Civil Air Regulations Amendment 3-7

**PART 3—AIRPLANE AIRWORTHINESS;
NORMAL, UTILITY, AND ACRO-
BATIC CATEGORIES**

**Miscellaneous Amendments Resulting
From First Airworthiness Review**

FIG. 3-12(b)
 BASIC LANDING CONDITIONS

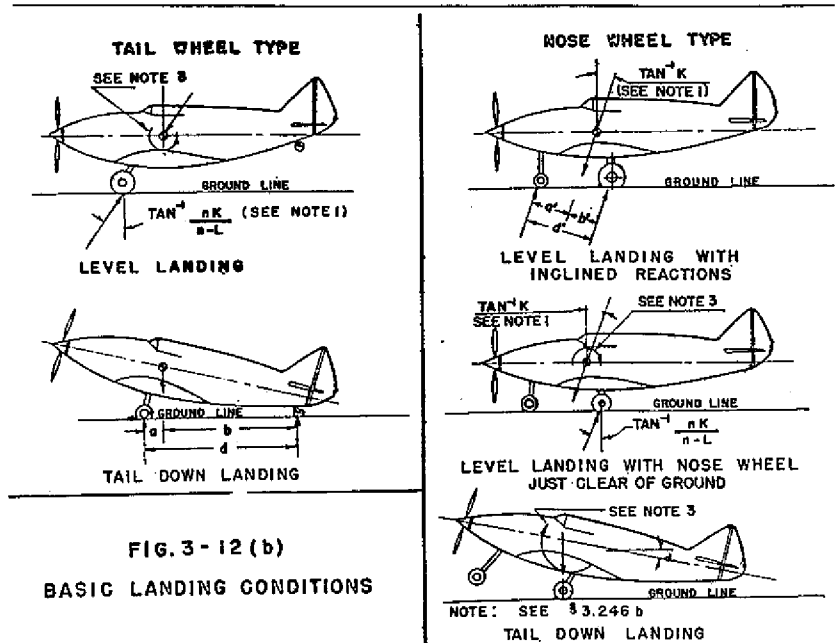
Miscellaneous changes of an editorial or clarifying nature are being made to §§ 3.1, 3.11(b), 3.82, 3.86, 3.174-1, 3.174-3, 3.174-7, 3.216-5, 3.216-6, 3.301, 3.301-1, 3.301-2, 3.304-1, 3.345-3, 3.573, 3.582, 3.714, 3.744, 3.745, 3.746, 3.747, 3.767, 3.779, 3.780, 3.780-1, Figure 3-12(b), and the heading of subpart E. The miscellaneous amendments contain an amendment to § 3.11(b) which excludes from the provisions of that section consideration of provisional type certificates. It was proposed that this be accomplished by a note. However, it now appears to be more appropriate to include such a provision within § 3.11(b) rather than as a note thereto. Although not contained in the proposal, the heading of subpart E is being corrected to read "Subpart E—Powerplant".

16. By amending Figure 3-12(b) referred to in § 3.244 as follows:
